RE: LLFA Response – 6/2020/3222/MAJ, Former Volkswagen Van Centre, Comet Way, Hatfield, AL10 9TF

Thank you for sending the re-consultation letter from Hertfordshire County Council (HCC) as Lead Local Flood Authority (LLFA) dated 14th July 2021, regarding the planning application reference 6/2020/3222/MAJ, Former Volkswagen Van Centre, Comet Way. It is disappointing that despite the LLFA acknowledging that we are providing significant betterment through reduction in runoff rates and the use of SuDs techniques for the proposed development, there is still insistence on providing further restriction to lower greenfield rates.

RE: 6/2020/3222/MAJ – Former Volkswagen Van Centre, Comet Way, Hatfield, AL10 9TF

CELLULAR STORAGE DETAIL
NTS

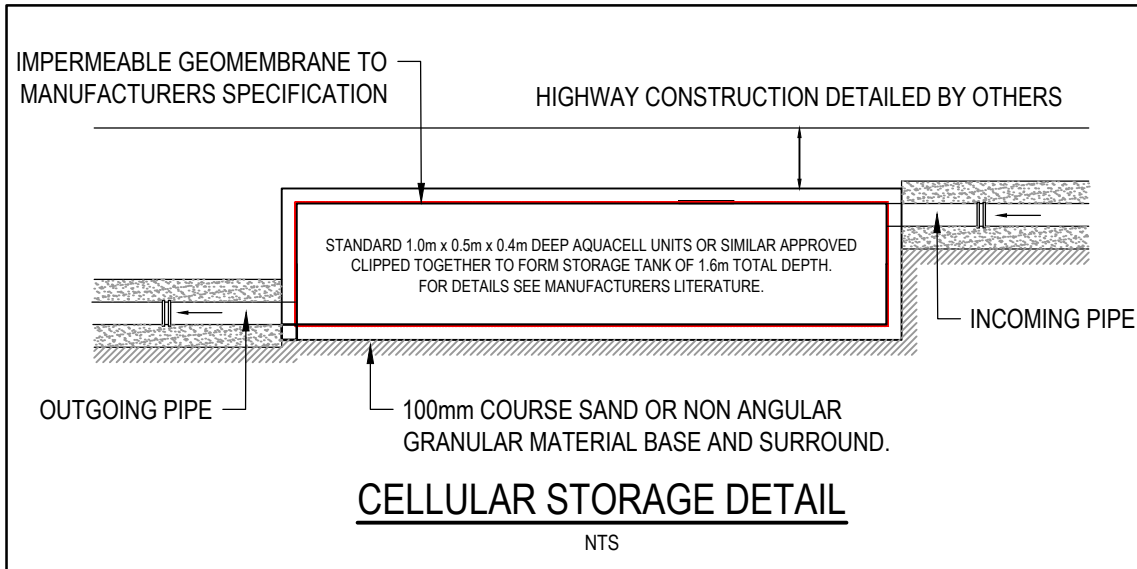
We acknowledge that the applicant is providing significant betterment however as per our previous comments the discharge rate should be restricted to the greenfield runoff rate for the relevant rainfall event, or to the Qbar rate. We acknowledge the 1 in 1 year and Qbar rates are low and may be difficult to achieve therefore we would accept a maximum of 2 l/s.

Although we feel the request by HCC to limit discharge rates to 2 l/s is unreasonable, we attach updated MicroDrainage calculations applying the restriction of this lower runoff rate. This demonstrates that the size of the tank would need to be increased from 34m² to 75m².

We have reviewed this against the space available within the adjacent parking area and to provide a tank of this size would require wrapping the tank around the building with a smaller easement and offset than we had previously shown (reduction of 1.7m). The size of the tank would be of a larger scale and likely to result in higher maintenance and tank replacement costs, especially with the offsets to the proposed building and underground services. Our drainage strategy drawing has therefore been updated to provide this larger tank as required by HCC.

As mentioned in our letter of 01 June, increasing the size of the tank, by increasing its depth, is not feasible because of the proposed outfall connection into the existing surface water sewer located in Goldsmith Way. Currently we achieve a gravity fed connection to this existing sewer at self-cleaning velocity. A deeper tank would prevent this and would therefore not conform to the recommendations within Sewers for Adoption.

47179/4001/002 Rev B

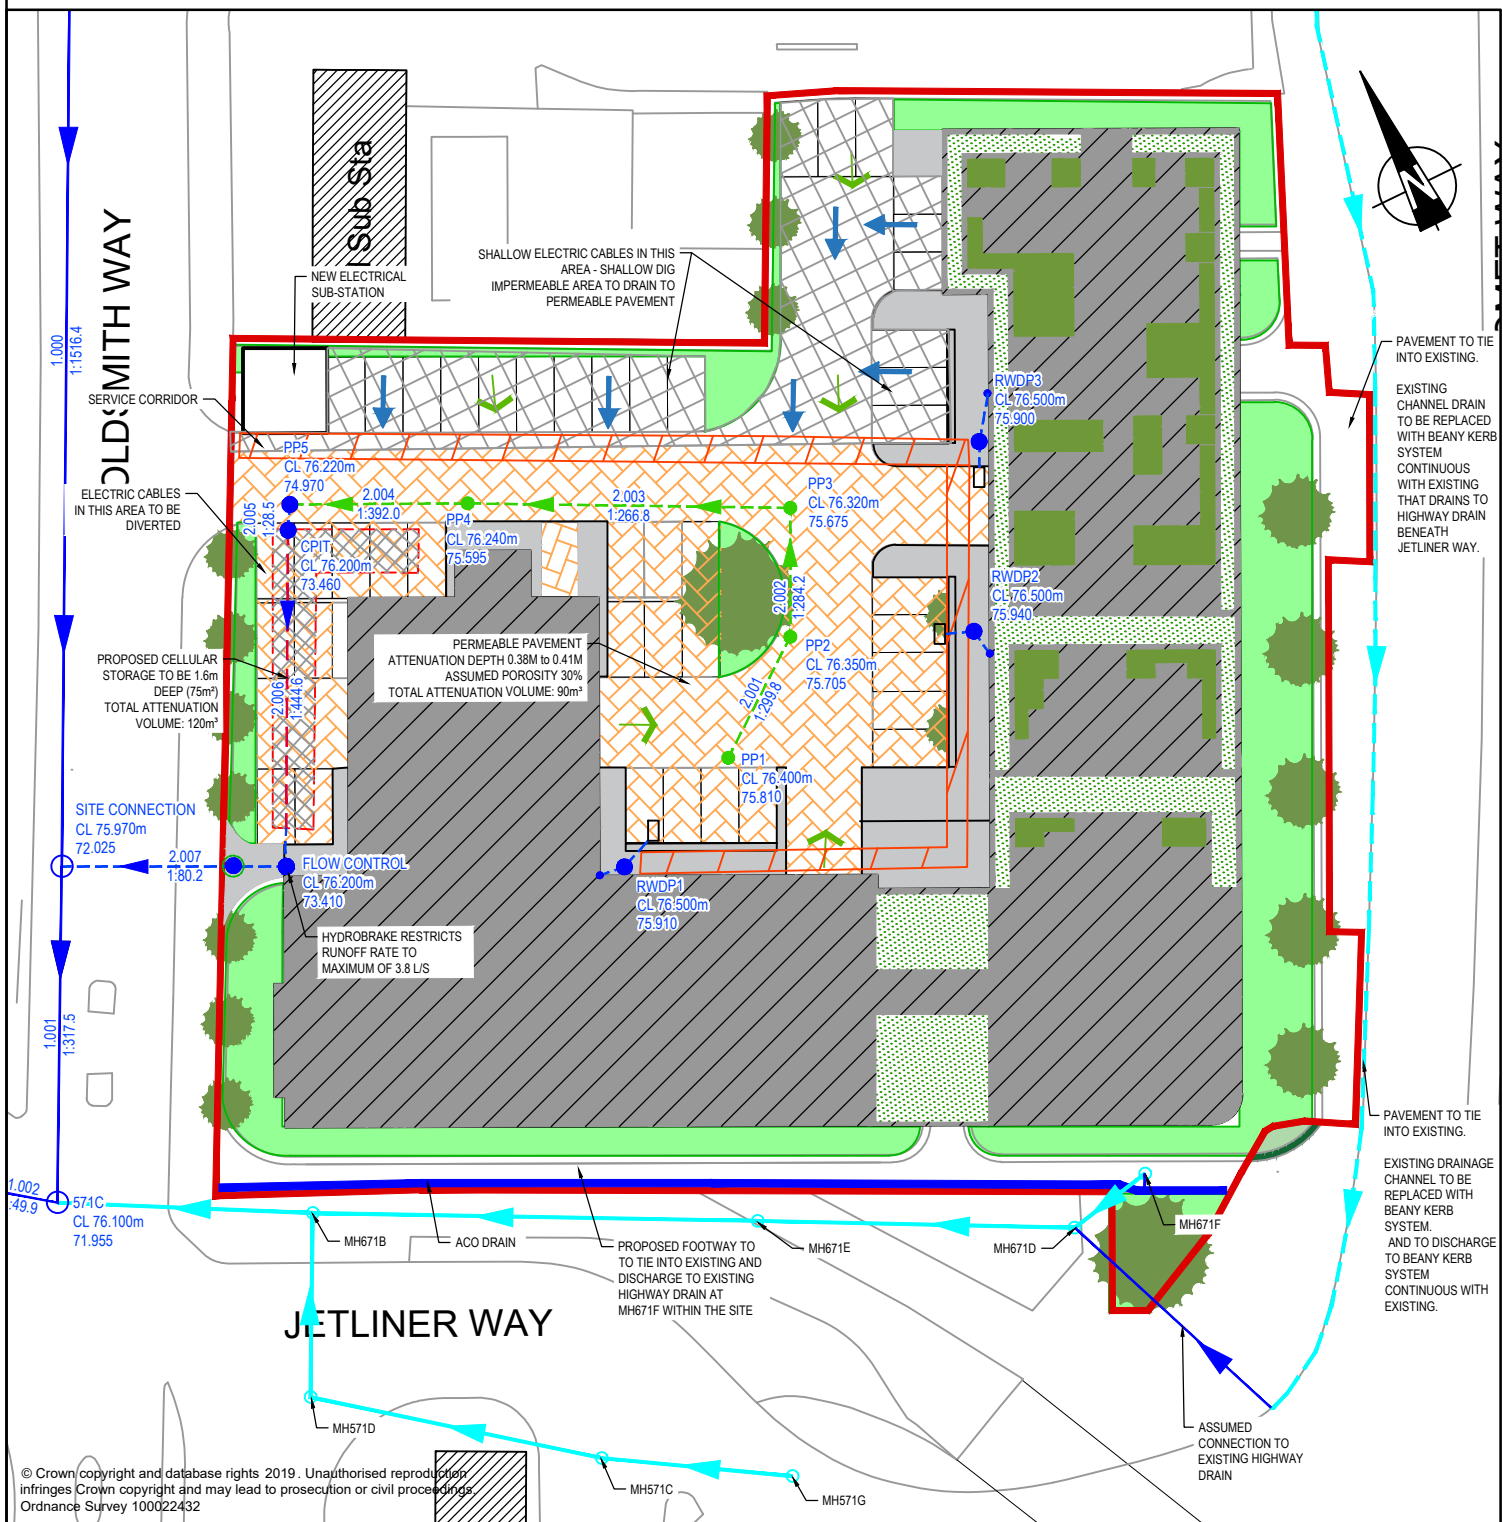
3. LLFA comment – Drainage of Footpaths along Site Boundaries

“3. We acknowledge the impermeable area of car parking spaces will drain to adjacent permeable paving areas.

The applicant has clarified that the footpath areas to the east and south of the building are proposed to drain unrestricted to existing highway drains in Comet Way and Jetliner Way.

As these areas are within the red line boundary they should be included in the drainage proposals and discharged at a controlled rate (as above) to an appropriate location.

Please note that if it is proposed to drain these areas to highway drains that we would require evidence of agreement in principle from Highways confirming they are happy to accept discharge into their network.”

As mentioned, and illustrated in our previous response (01 June), the external (outer edge of the proposed building) of existing and retained footpaths are to operate as the existing scenario, these were referenced on the drainage strategy drawing issued with our letter.

The areas of existing carriageway footpath adjacent to the existing boundary of the site are dropped kerb and drain to a channel drain along the road edge and then to the adjacent beany kerb system. This system then likely drains to the highway drain at MH671F within the south-eastern corner of the site as shown on the attached Thames Water sewer records. This highway drain then connects to the Thames Water public surface water sewer to the south-west of the site at MH571C.

Whilst an existing footpath isn't currently present along the southern boundary of the site, this area is predominantly impermeable and drains to this highway drain as proven by the services survey to either MH671F or MH671B, as shown in our letter dated 01 June. It is therefore proposed to dispose of surface water runoff unattenuated via an aco-drain channel along the southern edge of the new footway to MH671F prior to discharge into the existing drainage system.

The drainage drawing has been updated and appended to our letter to further highlight the drainage for these locations.

Given the shallow nature of the proposed surface water drainage system within the site, it would not be possible to connect these areas into the proposed system via positive drainage and it would also require the draining of these areas under the proposed buildings causing a significant maintenance issue.

As HCC are also aware, these external areas would be adopted and therefore it would not be possible to drain the footpaths to a private drainage system.

The existing carriageway footpaths connect into the existing highway system and therefore we see no reason to deliver anything different.

For the avoidance of doubt, we have consulted the Highways Authority on this matter, and we are awaiting a response. However, it would be reasonable for this to be conditioned and the design of these areas would form part of a future agreements with the highway authority.
